# SKETCH PLAN OF SERENITY AT RIVERS EDGE

P.I.D.#34-32-25-14-0029

### 1 - Floodway and Flood Fringe

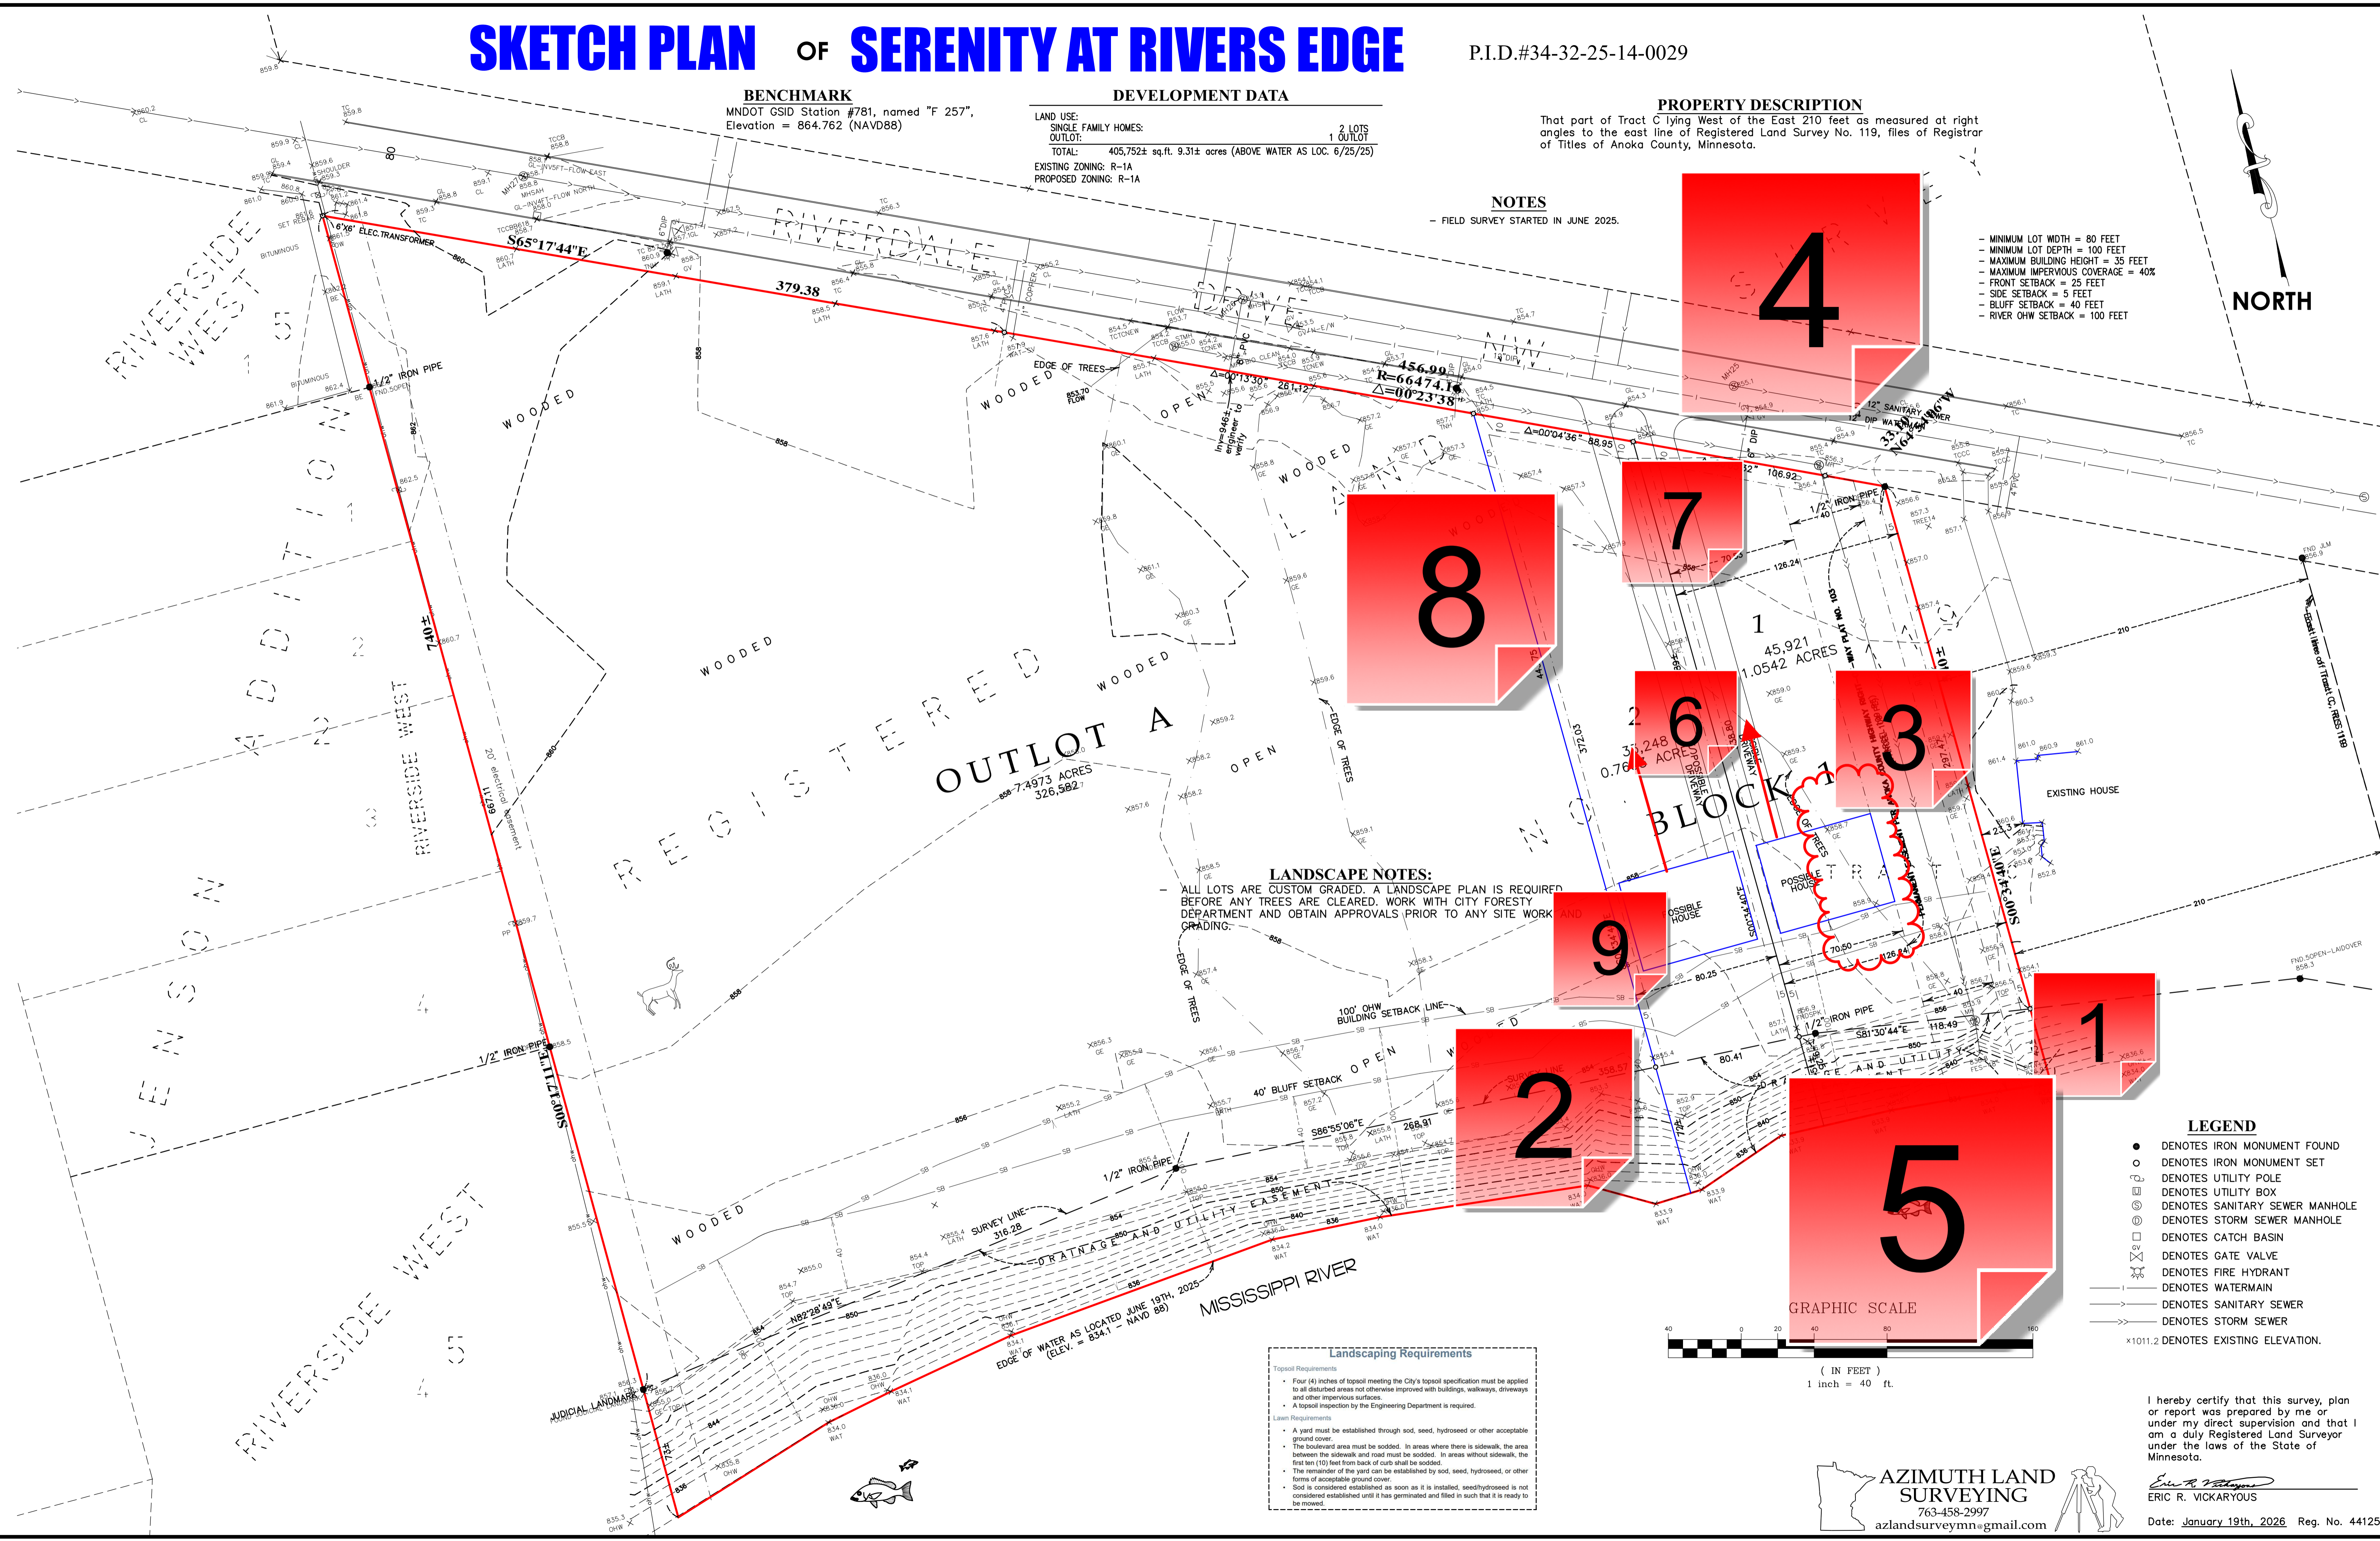
Please add the boundaries of the floodway and flood fringe from FIRM Panel 27003C0281E, dated December 15, 2015. Because of the presence of floodplain, an As-Built Grading Certificate and/or an Elevation Certificate shall be required prior to issuance of a Certificate of Occupancy to verify the lowest floor elevation complies with floodplain standards. This will also benefit the buyers as it will make it clear the homes are outside the floodplain boundary and thus, it would eliminate the federal mandate for floodplain insurance.

The Shore Impact Zone (SIZ) begins at the Ordinary High Watermark (OHW) and extends into the land fifty (50) feet. Vegetation management standards found in City Code Section 106-910 (i) apply.

No part of the eave overhang can encroach into this d/u easement.

Please add a density calculation for the proposed lots.  
Add the floodway and flood fringe boundaries.  
Add the Shore Impact Zone boundary (50% of the required setback, so the SIZ is 50' from the OHW).

There are multiple Significant Existing Vegetative Stands present on the property. Thus, a detailed project description must be provided and the Significant Existing Vegetative Stands must

be identified on the Sketch Plan. Use this map to locate the Significant Existing Vegetative Stands:  
<https://arcgis.dnr.state.mn.us/portal/apps/instant/basic/index.html?appid=a74ce8dcc819434588a4fc5204187dee>

Per the MRRCA regulations, only the minimum tree removal necessary to accommodate development is permitted.

City Code Section 106-430 ([https://library.municode.com/mn/ramsey/codes/code\\_of\\_ordinances?nodid=PTIICOOR\\_CH106ZOCO\\_ARTIVREDI\\_S106-430BUST](https://library.municode.com/mn/ramsey/codes/code_of_ordinances?nodid=PTIICOOR_CH106ZOCO_ARTIVREDI_S106-430BUST)) states that the maximum front setback for the R-1A district is 35 feet. However, there is a caveat that would allow the houses to meet the existing setback pattern of existing homes.

Both house pads should be shifted north to match the existing setback pattern of the homes to the east. Additionally, this will create more separation from the 100 foot setback boundary from the OHW, potentially allowing more space for future homeowner improvements, such as a deck/patio, swimming pool, etc. This also likely reduces the number of trees needing to be removed on Lot 1 (at least for initial construction of the home).

The driveways should have some curvature to them to 'snake' through the trees, minimizing to the extent possible how many need to be removed. Plus, this will create more privacy as those homes would be better screened from Riverdale Drive.

A tree inventory and preservation plan is required with the final plat application. While this could cover the entire site, it could also just focus on Lots 1 & 2 and exclude the outlot for now. All oaks and evergreens that are 4" or greater in diameter, and all other trees that are 8" or greater in diameter shall be included in the inventory and it should include species (not just oak, pine, elm, but red oak, bur oak, red pine, white pine, American elm, Siberian elm, etc.), diameter, status (saved or removed), and brief description of why it's being removed (general grading, stormwater basin, etc.). Any deviation from the standard tree inventory process would require a variance.

Decks and patios are subject to the 100 foot setback from the OHW also. There is a provision built in that decks and at grade patios can encroach into the required 100 foot setback from the OHW up to 15 feet without the need for a variance as long as it remains compliant with the vegetation management and land alteration standards.
